MONTGOMERY COUNTY PLANNING DEPARTMENT

MCPB
Item # 5 C
11/12/09

SUBJECT: Mandatory Referral No. 2009707-MCPS-1
Fairland Elementary School Addition
Fairland Planning Area

STAFF RECOMMENDATION: Approval to transmit the following comments.

Attachment B – Proposed Site Plan

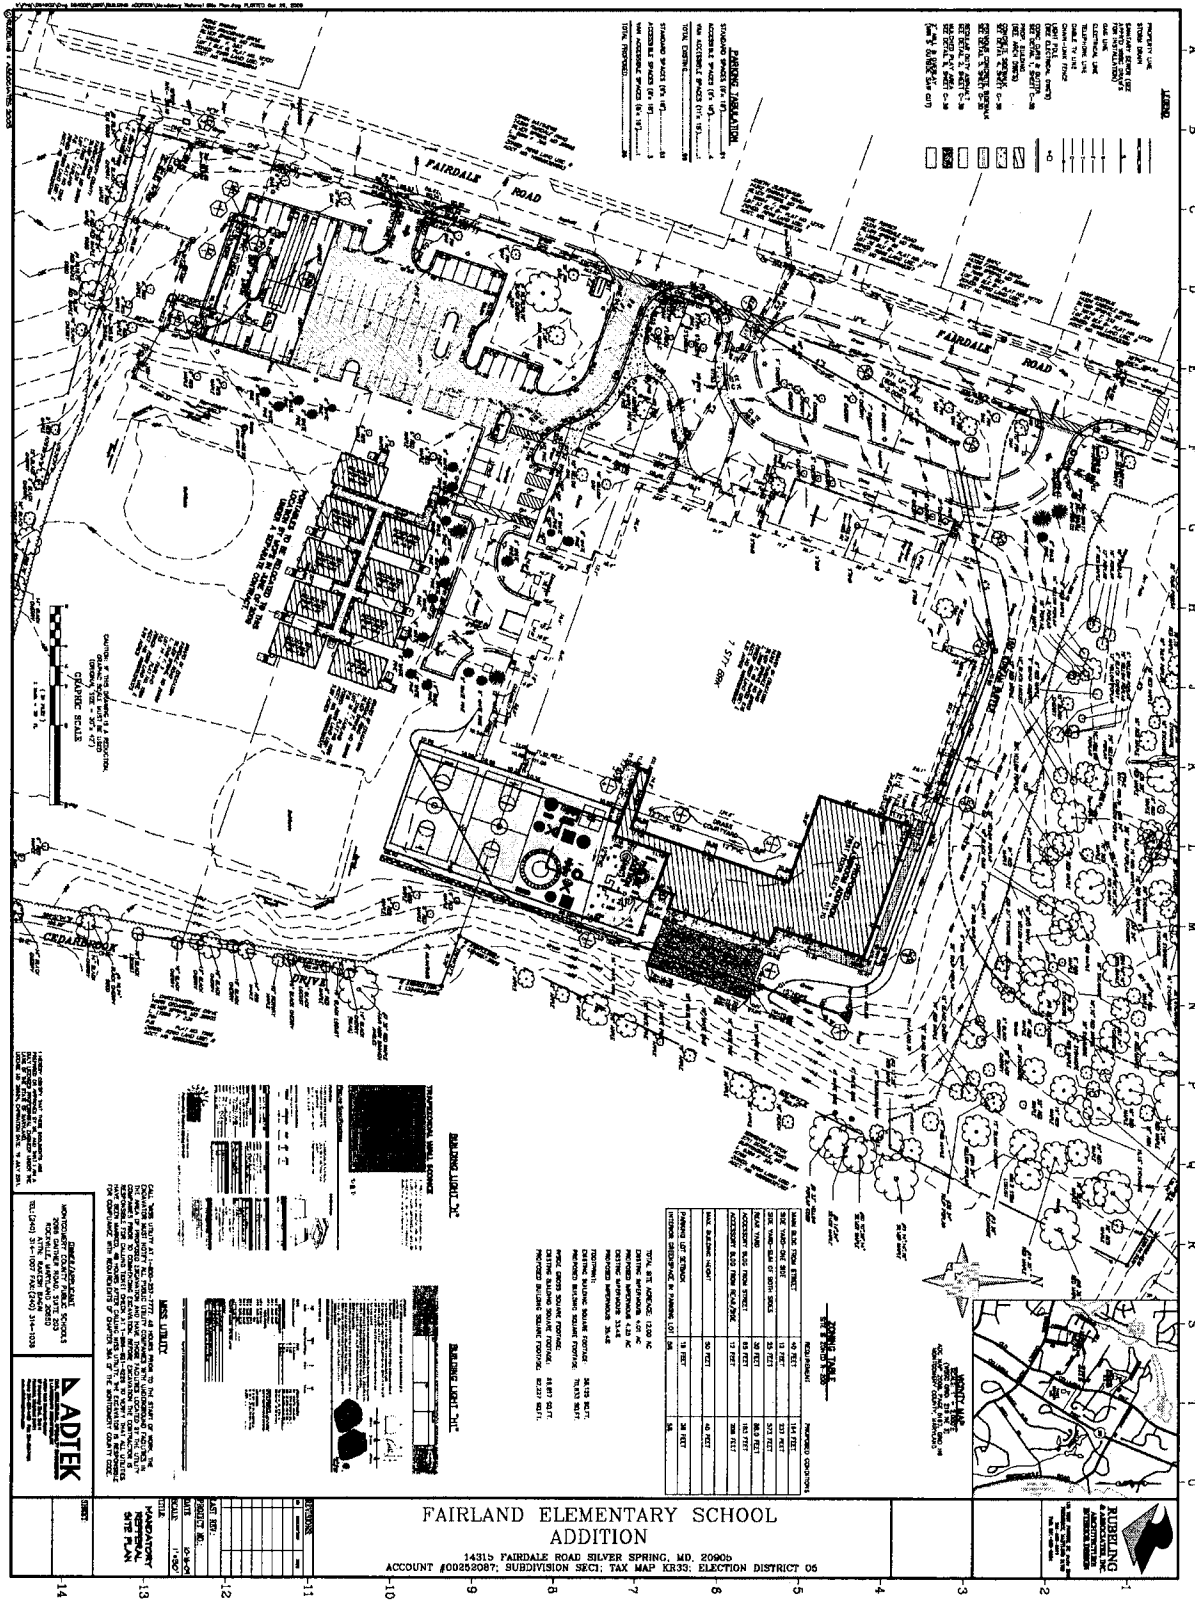
Pedestrian Circulation: The existing pedestrian system includes a sidewalk along Fairdale Road and connecting sidewalks to school entrances. There is a need to provide a continuous sidewalk around the school to facilitate convenient access to ball fields and play areas. An additional sidewalk link around the back of the proposed classrooms should be pervious pavement to not increase imperviousness area.

1. Provide a 160 long foot sidewalk connection around the new addition using pervious pavement.
2. Any mandatory referral submission for future improvements at the school by MCPS must include a traffic study for Adequate Public Facilities (APF) purposes if those improvements at the school will result in a core capacity that is greater than 740 students.
3. Manage parent drop-off/pick-up of students entirely within the school property and discourage any drop-off/pick-up of students along Fairdale Road or other neighboring streets.
4. Coordinate with Montgomery County Department of Transportation (DOT) to assess the feasibility of constructing sidewalks along the east side of Fairdale Road between Briggs Chaney Road and Bradshaw Drive through County's Annual Sidewalk Program or through CIP Project No. 509036, Transportation Improvement for Schools.

Attachment C – Proposed Landscape Plan

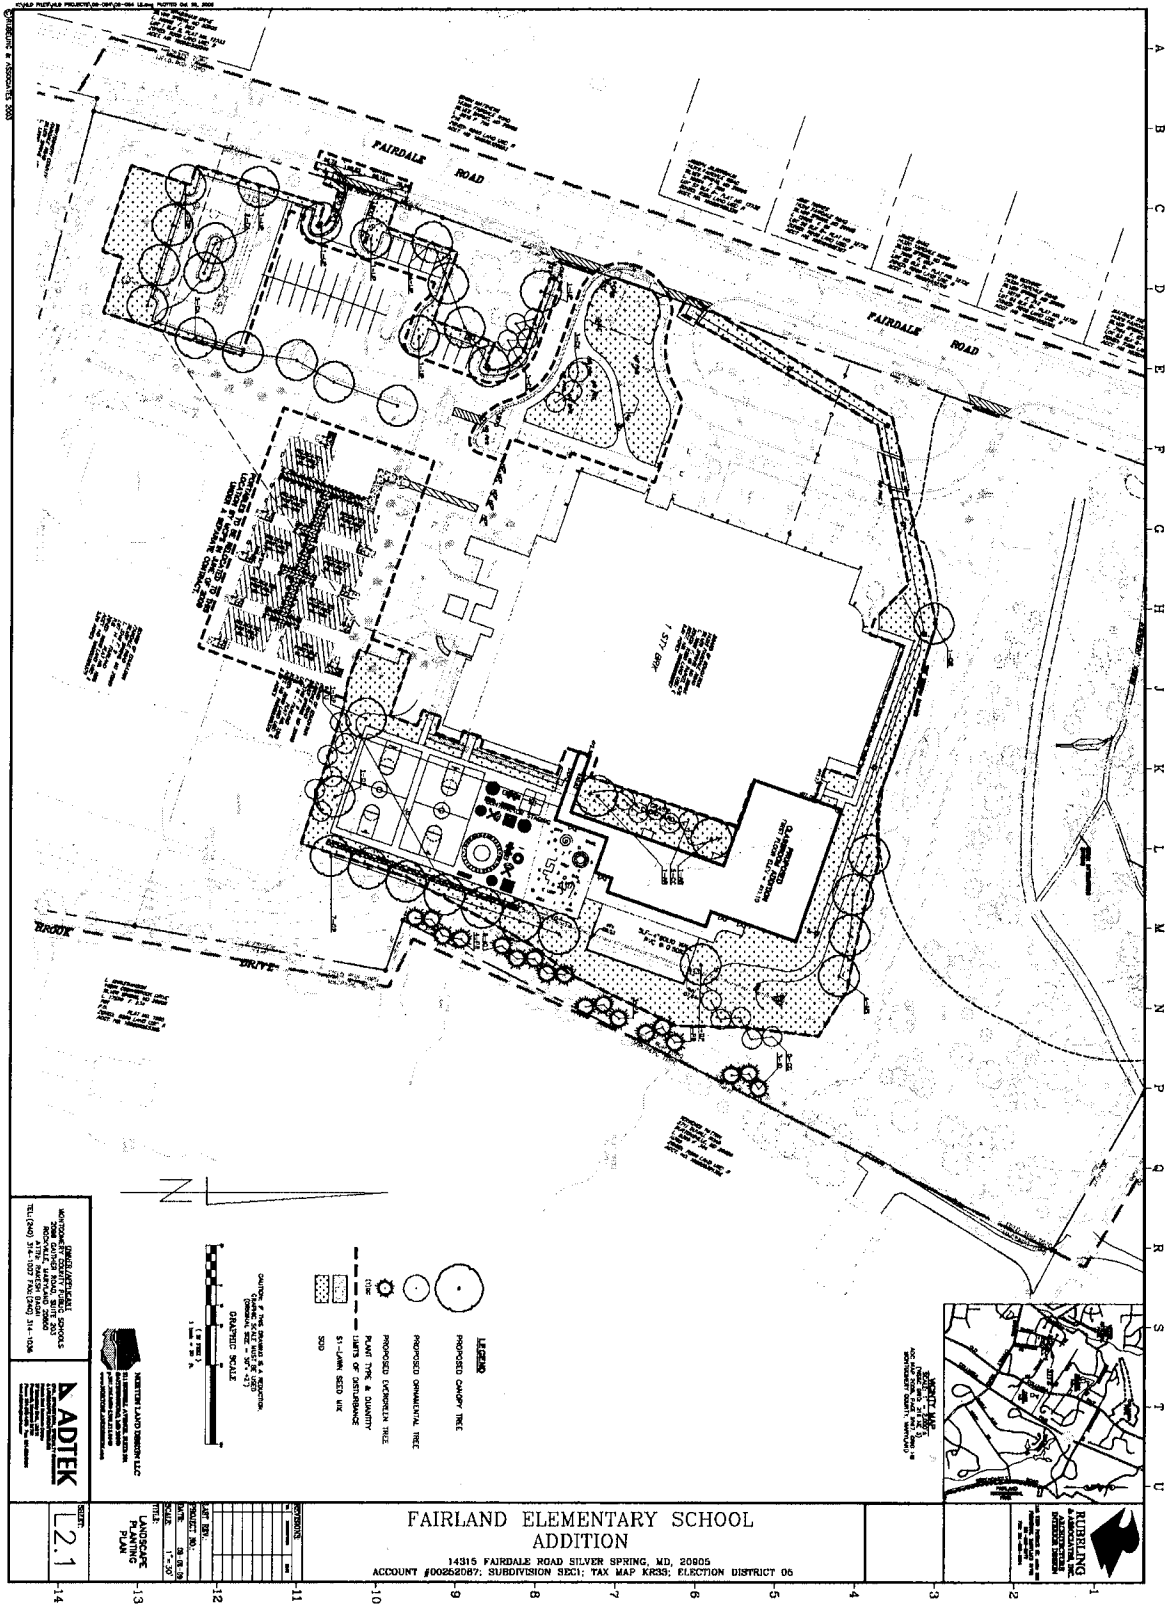
4. **Landscaping:** The proposed plan provides adequate on-site landscaping surrounding the parking areas and along the rear yard buffering the nearest residence. The closest residence along the rear property line is 200 feet away. The existing vegetation supplemented with the proposed screening will establish a compatible relationship. The existing woodland to the north and south of the school's property requires no additional landscape screening.
